CALIFORNIA COASTAL COMMISSION

SUBJECT: **Proposed Major Amendment (2-97)** to the Pepperdine University Long Range Development Plan to be reported at the February 5, 1998 Commission Meeting at Quality Resort - Mission Valley, 875 Hotel Circle South, San Diego.

**PEPPERDINE UNIVERSITY
LRDP AMENDMENT 2-97
AND
NOTICE OF IMPENDING
DEVELOPMENT 2-97
EXHIBITS**

View of Proposed Earthen Stockpile Area from Equestrian Center and Rendered Stockpile Simulation

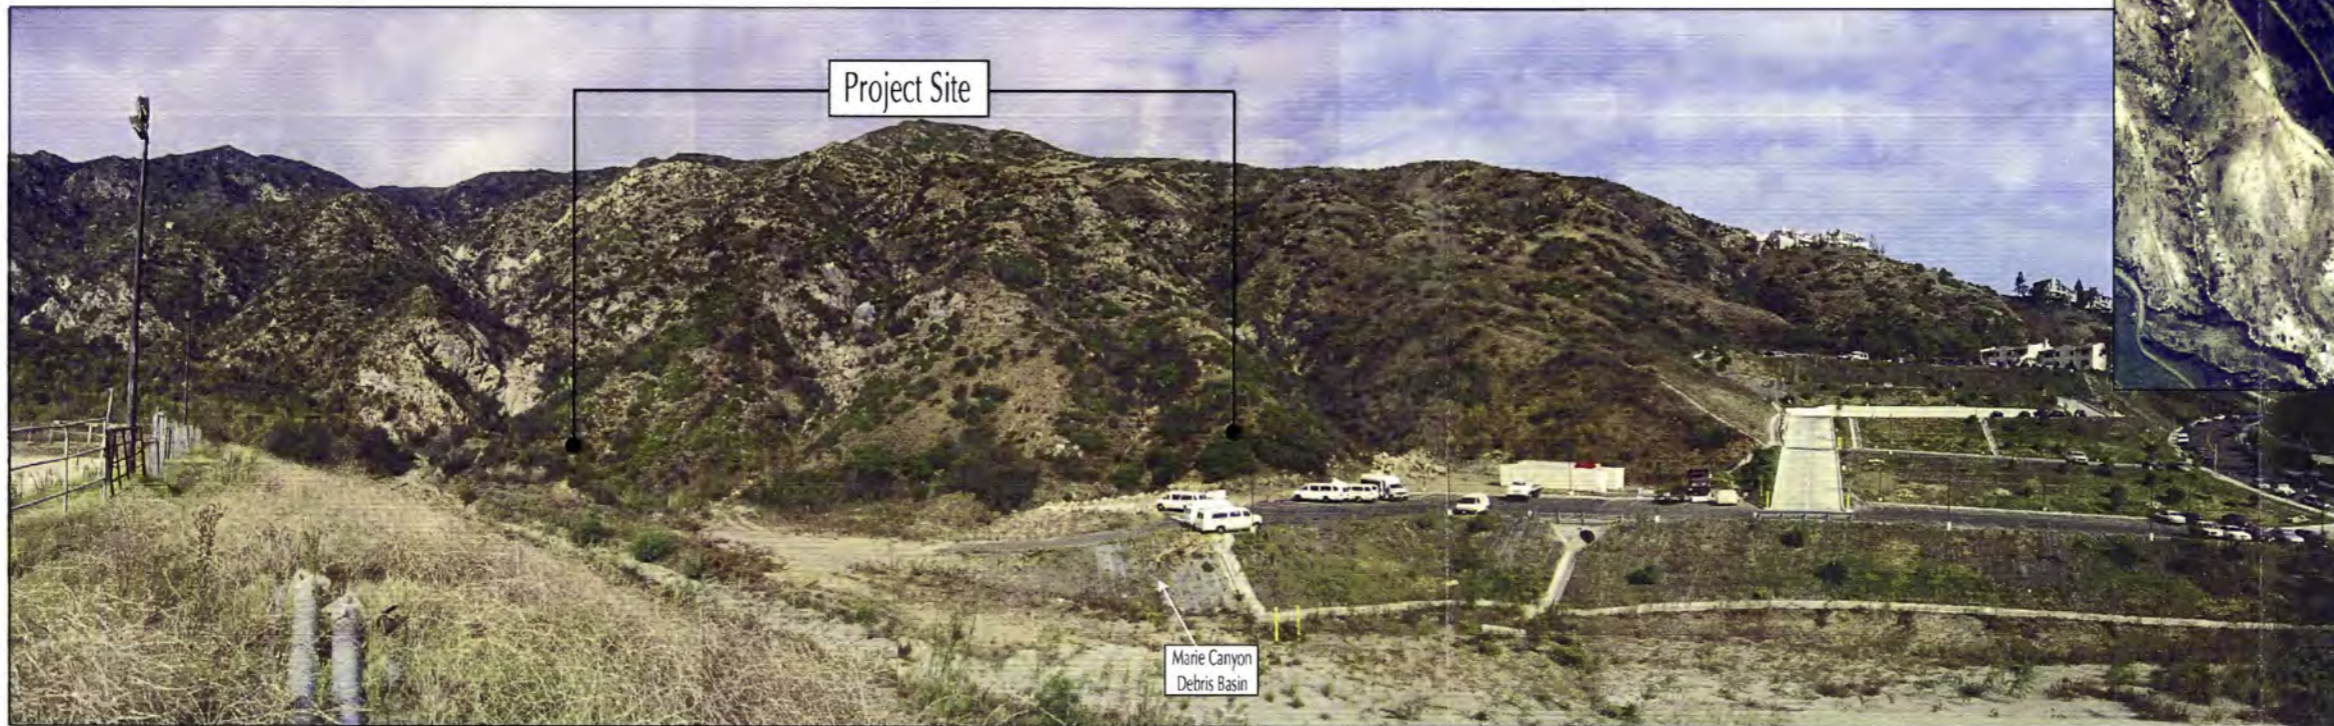
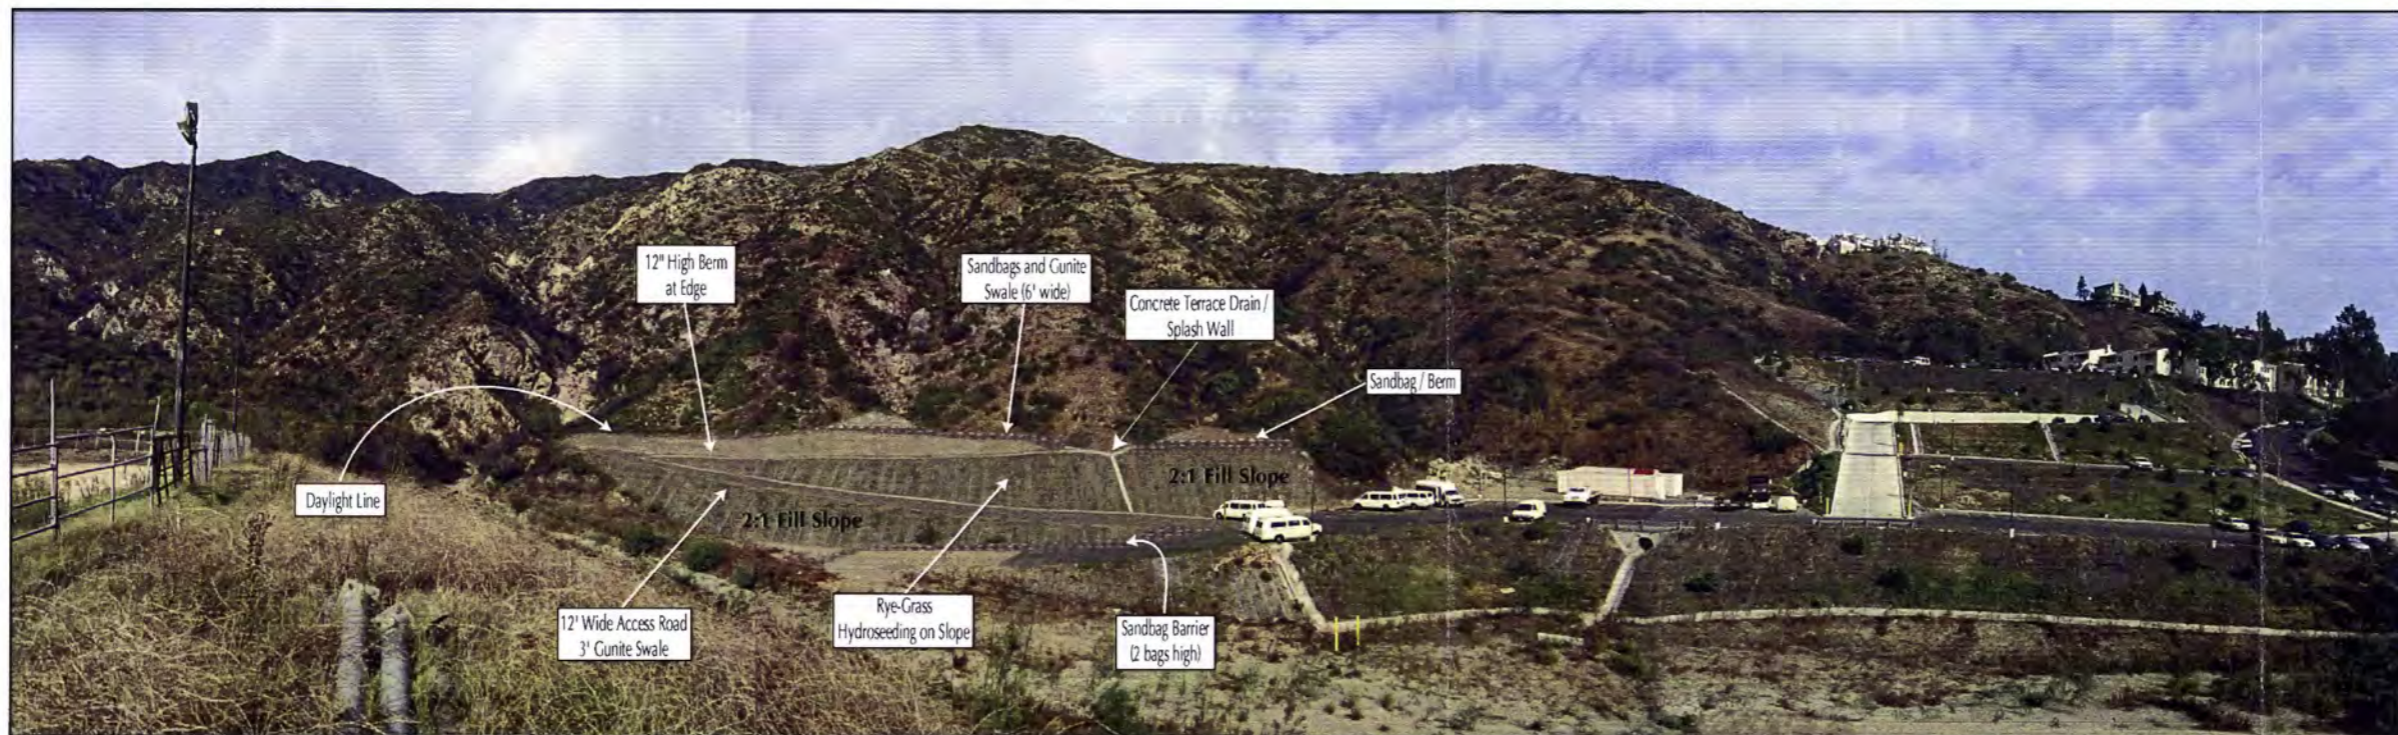
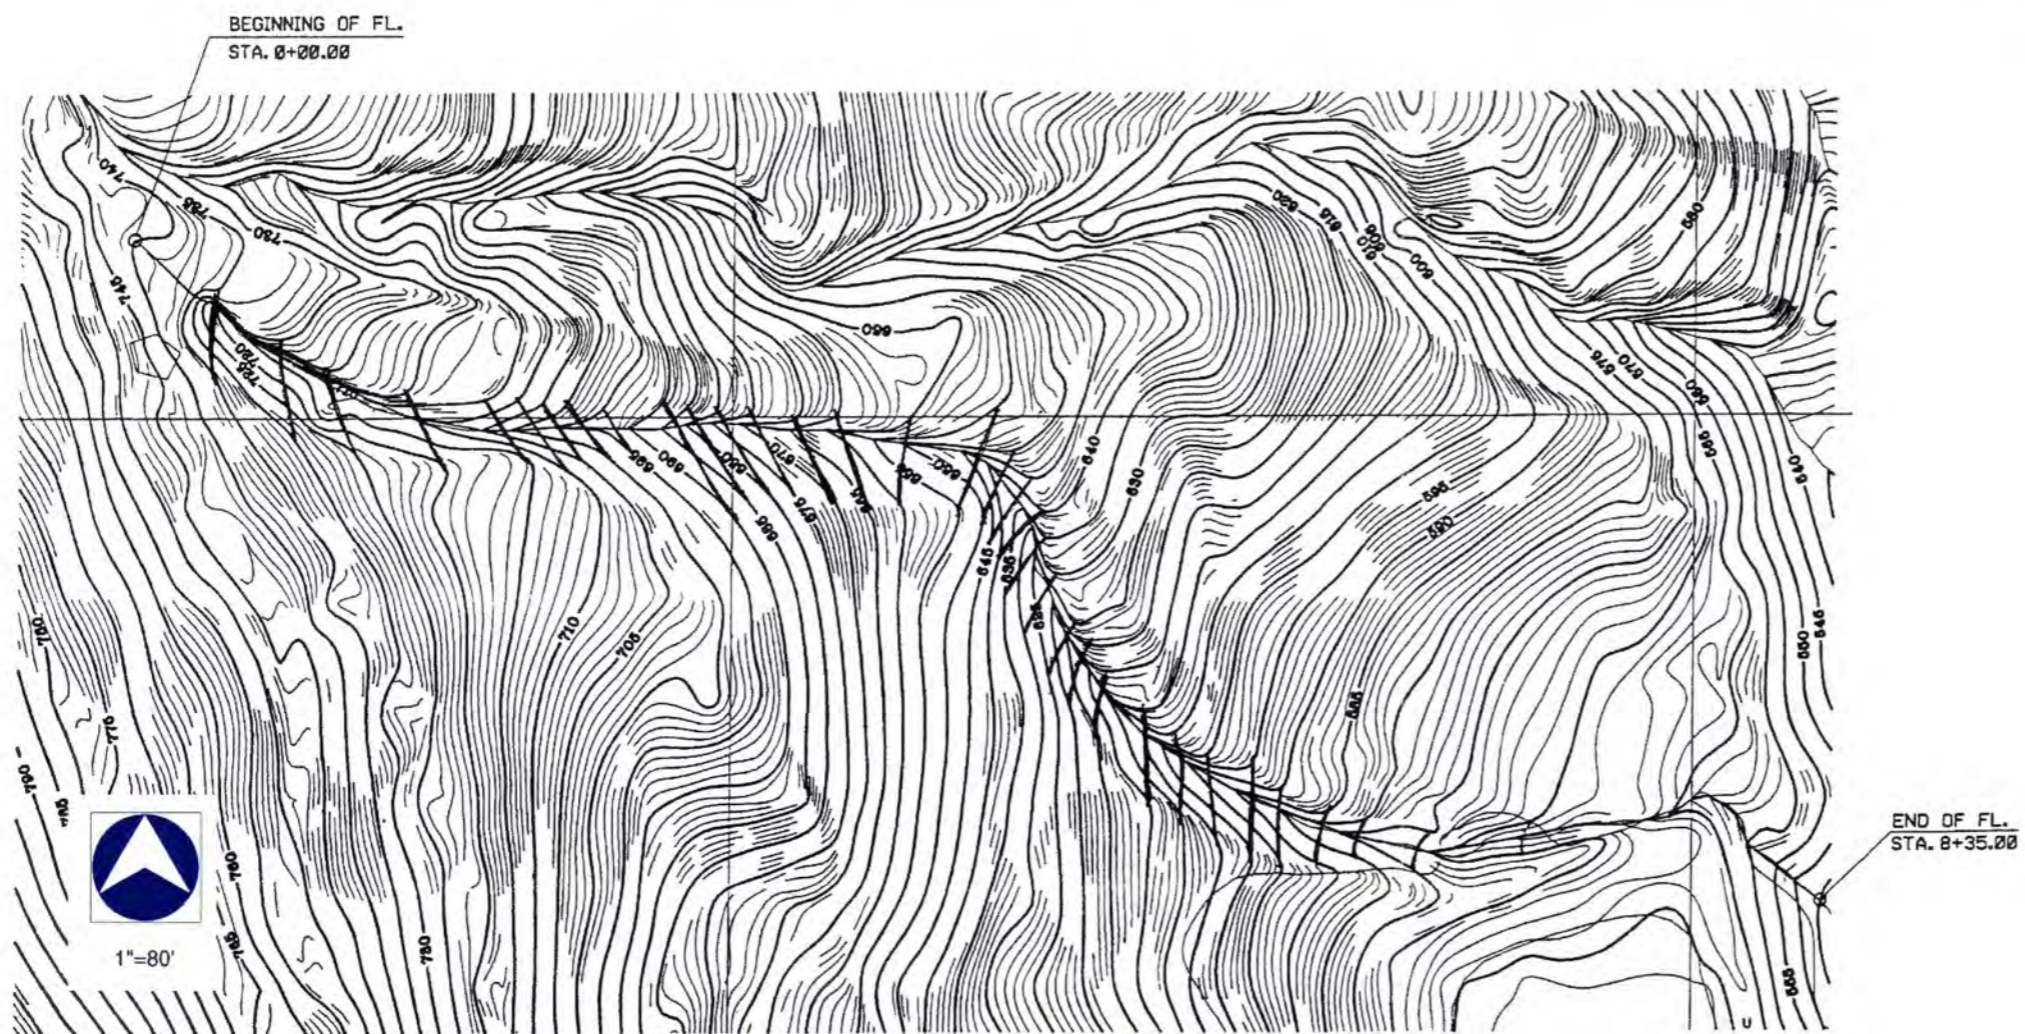
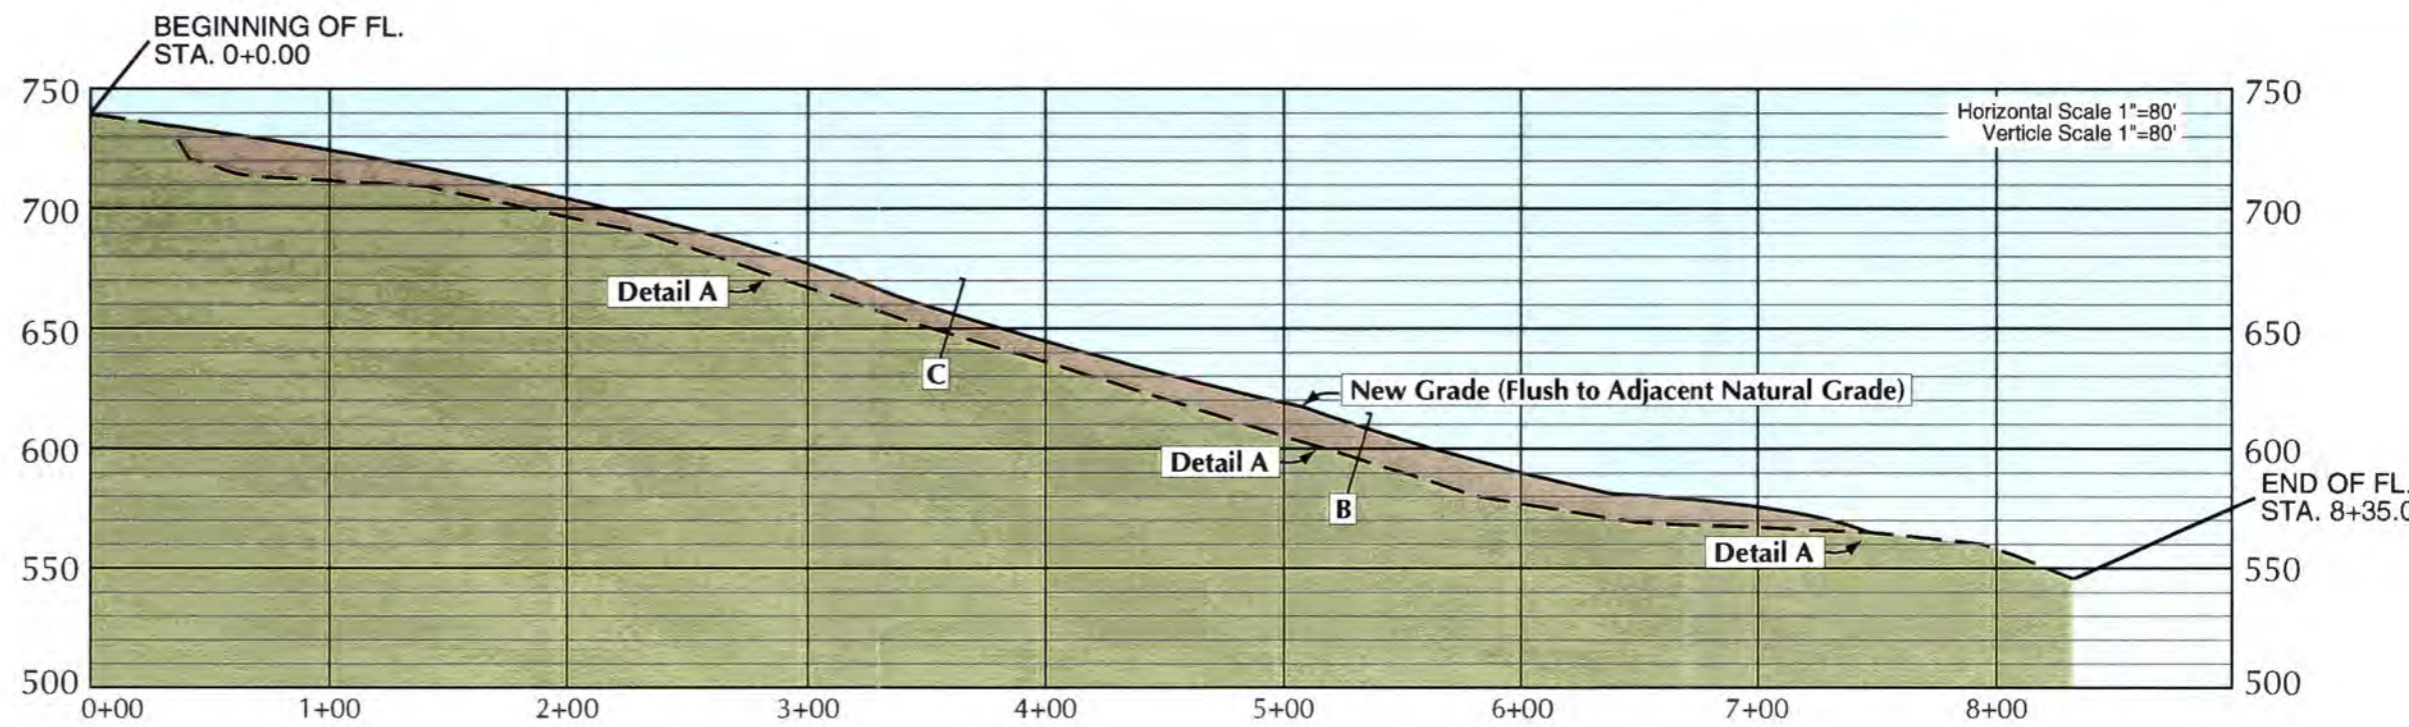
The University has submitted a computerized photo (Figure 4) to illustrate a possible worst-case buildout (Phase III) of the stockpile. The stockpile would be maintained as a 2:1 slope and accessed by a 12-foot unpaved road from its southern boundary to its northern boundary. Primary erosion/air quality control measures include hydroseeding with rye grass, sandbags, berms, gunite swale, concrete terrace drains, and splash walls. Each is described in detail above, and on the stockpile grading plan.

Public views directed toward the proposed project site from Malibu Bluffs Community Park encompass sweeping vistas of the Santa Monica Mountains that also contain the most prominent of Pepperdine University's structures on the foreground grassy slopes which border PCH. As illustrated in **Figure 4**, the project site is situated behind elevated, on-campus ridgelines which block potential project site visibility from locations in the park.
